Ashton-Ravensworth Underground Mine Integration Modification

Ashton Coal Project

SUBMISSIONS REPORT

Chart 1
Predicted Post-mining Indirect Take from Surface Water and Alluvial Sources

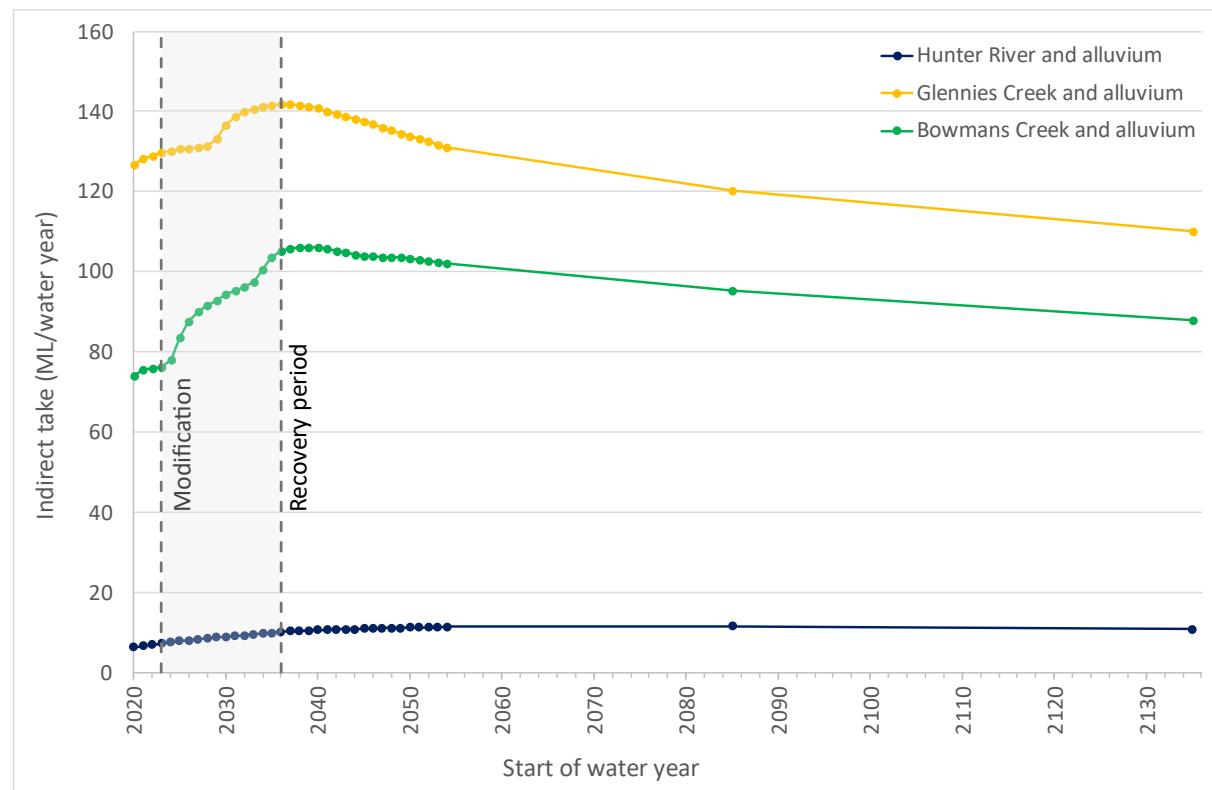
DPIE – Water noted that ACOL has not outlined a strategy to account for any water taken beyond the life of operation of the projects. Relevant water access licence entitlements would need to be retired at the completion of the Projects to account for groundwater take during the recovery of the groundwater system, post-mining. DPIE – Water requested that Yancoal provide the details on the predicted peak take post-mining and reconcile this take against the water access licences (WALs) held.

Predicted post-mining water take has been modelled by AGE using the same groundwater model peer reviewed by Dr Noel Merrick for the Modification, and is provided in Attachment 1. Chart 1 summarises the predicted post-mining groundwater take. A tabulation of the predicted indirect take from the surface water and alluvial sources for the modelled post-mining years is presented in Attachment 1.

During the post-mining period, inflows from the North Coast Fractured and Porous Groundwater Source into the completed workings would be less than the predicted peak take of 649.5 megalitres per year during mining (Attachment 1). While there is a minor increase in take during the early post-mining period for the surface water and alluvial sources (Attachment 1), ACOL holds relevant WALs with sufficient entitlements (as summarised in Table 4.1 of the Groundwater Review) to account for the predicted post-mining water take. Where required, ACOL would retire relevant licence entitlements in consultation with DPIE – Water following the completion of mining at the Ashton Coal Project.

Figure 3.1 Total predicted indirect take for each water source over the life of modification

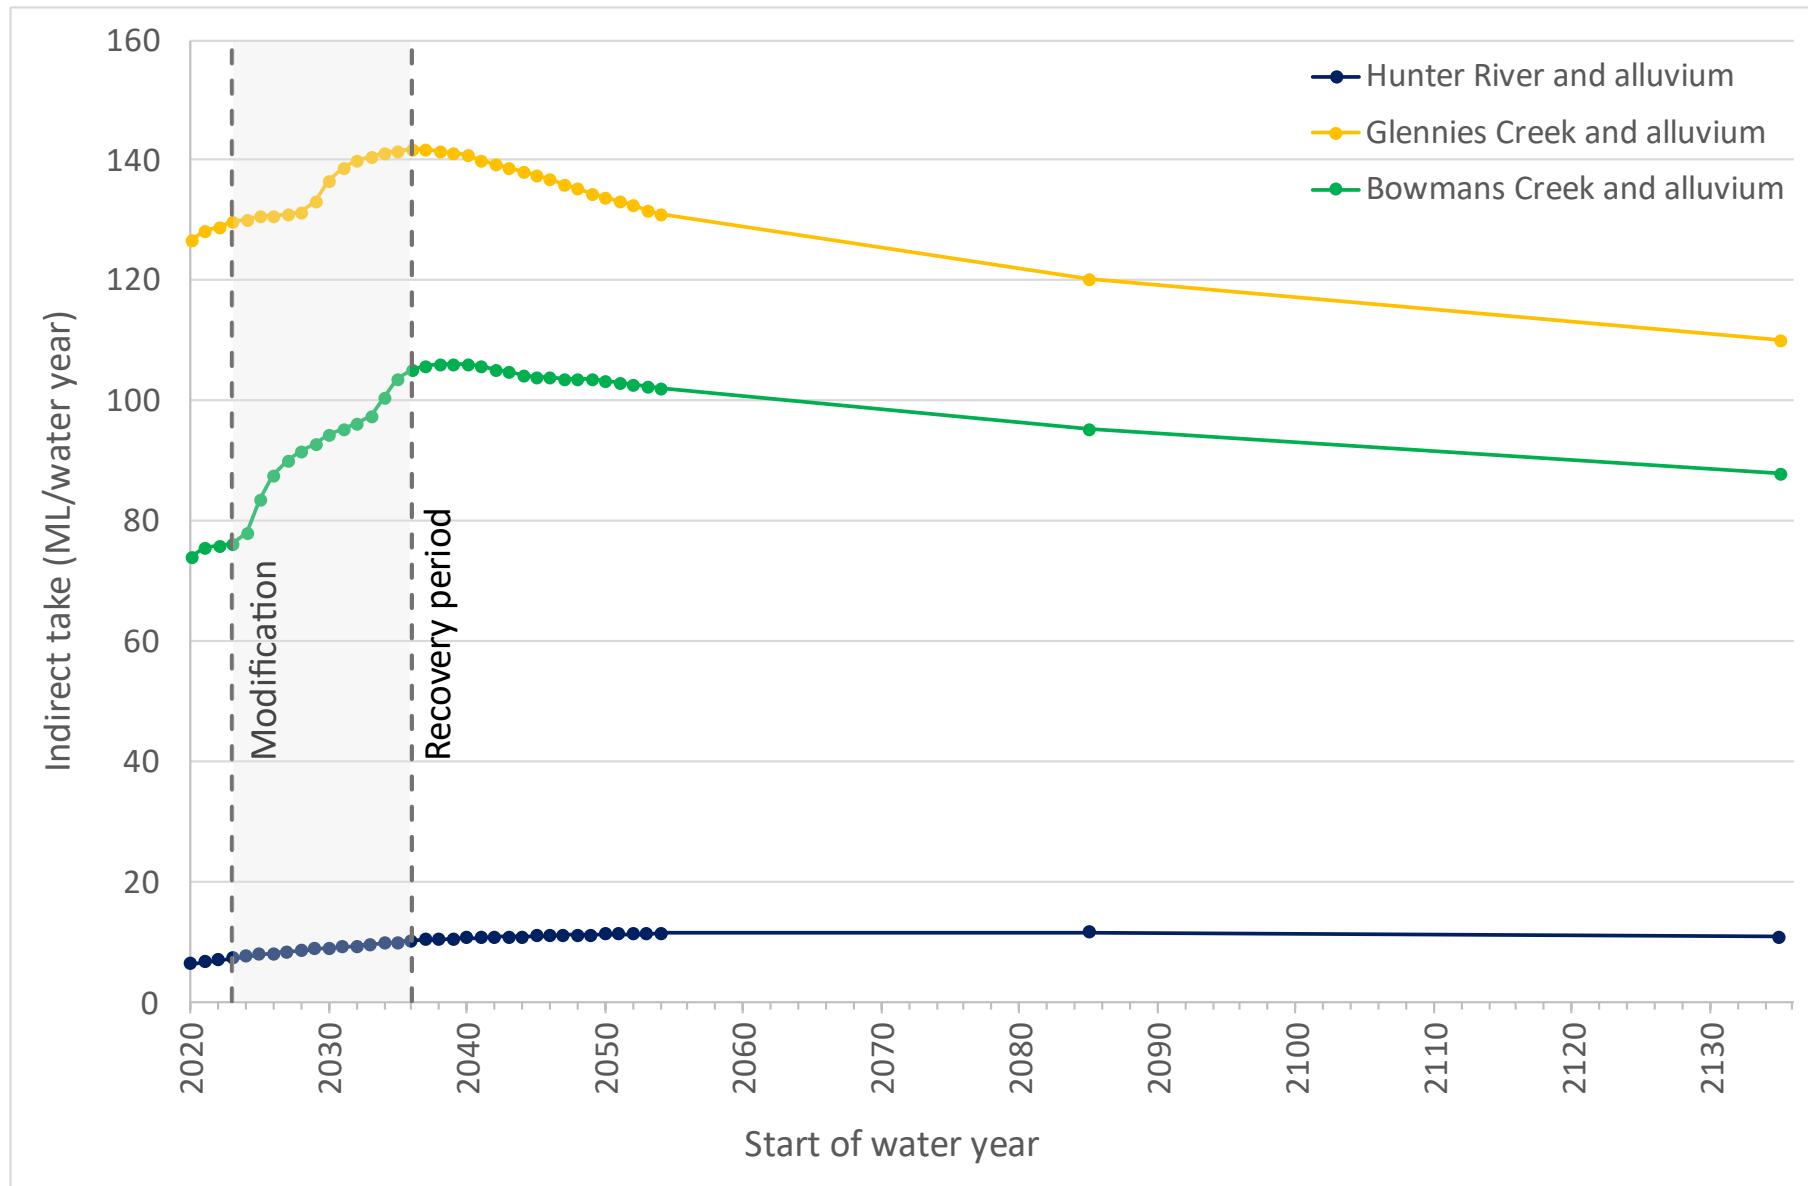
'The proponent has not outlined their strategy to account for any water taken beyond the life of the operation of the projects. Relevant water access licence entitlement would need to be retired at the completion of the Projects to account for groundwater take during the recovery of the groundwater system, post-mining. The peak take for the alluvial systems is presented in Figure 4.8 of the Groundwater Review and shows an increasing trend up to 5 years post-mining modelled period. The predicted peak take post-mining should be reported and reconciled against WALs held.'

'...provide the details on the predicted peak take post-mining and reconcile this take against the WALs held.'

The indirect take per river system, reported to peak by the end of simulation (December 2036) in AGE (2021), increased slightly early in the recovery period, before decreasing with time (Figure 3.1). The peak indirect take per water year occurred during the 2038-2039 water year for Glennies Creek and during 2039-2040 for Bowmans Creek (Figure 3.1; Table 3.2). The indirect take from the Hunter River system was stable, increasing annually by less than 0.1 megalitres per year (ML/year) from 2037-2038 through to the peak at 2085-2086, before declining thereafter.

ACOL holds WALs with sufficient entitlements to account for the peak predicted indirect take during the active mining and recovery periods.
